Arrangement Requirements for Combined Fire Detectors in Ro-ro Spaces and Special Category Spaces of Ro-ro Passenger Ships

Guidance for the Survey and Construction of Passenger Ships

ID:DX25-18

Amended-Original Requirements Comparison Table (Arrangement Requirements for Combined Fire Detectors in Ro-ro Spaces and Special Category Spaces of Ro-ro Passenger Ships)

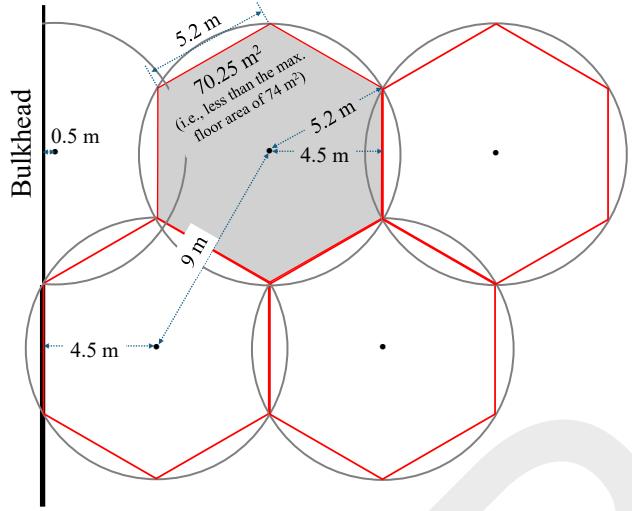
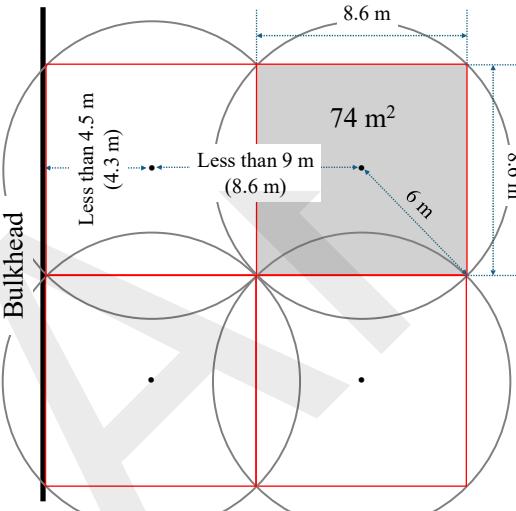
Adds reference examples of arrangements considered acceptable for combined detectors.

Number	FSS Code	Interpretations
(Omitted)		
FSS 9.2.4.2.2 & Table 9.1	<u>The maximum spacing of detectors shall be in accordance with the table below*:</u>	<p>*:</p> <p>The arrangement of combined smoke and heat detectors may be based on either (1) or (2) (See <u>MSC.1/Circ. 1695</u>):</p> <p>(1) <u>Arrangement based on the maximum permissible centre-to-centre distance of 9 m (See Fig. 7-1-B3 (1)).</u></p> <p>(2) <u>Arrangement based on the maximum permissible floor area of 74 m² (See Fig. 7-1-B3(2)).</u></p>
FSS 9.2.4.2.3	Detectors in stairways shall be located at least at the top level of the stair and at every second level beneath.	Detectors provided at inside the stairway enclosures are, in principle, to be installed on the ceiling of the upper deck of the two decks which are connected by the stairs (See <u>Fig. 7-1-B34(1)</u>). However, in cases where the stairway enclosure is continuous throughout the all decks, one detector is to comply with the requirements specified in 9.2.4.2.3 and to be located at every intervals not exceeding

Amended		Original	Remarks
		11 m (See Fig. 7-1-B34(2)).	
FSS 11.2.1	<p>(Omitted)</p> <p>Any <u>required low-location lighting systems</u> shall be approved by the Administration based on the guidelines* developed by the Organization, or to an international standard acceptable to the Organization.</p>	<p>*: Reference is made to ANNEX 7-3 - GUIDELINES FOR EVALUATION, TESTING AND APPLICATION OF LOW-LOCATION LIGHTING (hereinafter referred to as "LLL") ON PASSENGER SHIPS (IMO Resolution A752(18)). Furthermore, the requirement for electric LLL is to comply with the follows;</p> <ol style="list-style-type: none"> (1) The requirement for the electric power supply of emergency electric power source is to comply with paragraph 2.3, Part 6 of the Rules. (2) The power supply circuit to the LLL are to be arranged such that a single fault in the circuit does not result in the complete loss of the lighting in any fire zone and a fire in one fire zone does not result in loss of the lighting in any other fire zone. For this purpose, the power supply circuits are to be used the fire resistant cables complying with IEC Publication 331 or may supply by the independent batteries which located adequate place and can supply for LLL for at least 60 minutes. (3) Single lights and lighting assemblies are to be designed or arranged so that any single fault or failure in a light or lighting assembly, other than a short circuit, will not result in non visible area exceeding 1m in continuous lighting. (4) Lighting fixtures and assemblies are to be flame retardant as a minimum, have an ingress protection of at least IP55 and are to meet the type test requirements as specified in UR E10. (5) The LLL system is to be capable of being manually activated by a single action from the continuously manned central control station. However it may be acceptable by continuously operating or be switched on automatically, e.g. by the presence of smoke within the space(s) being served. 	Update figure numbers.
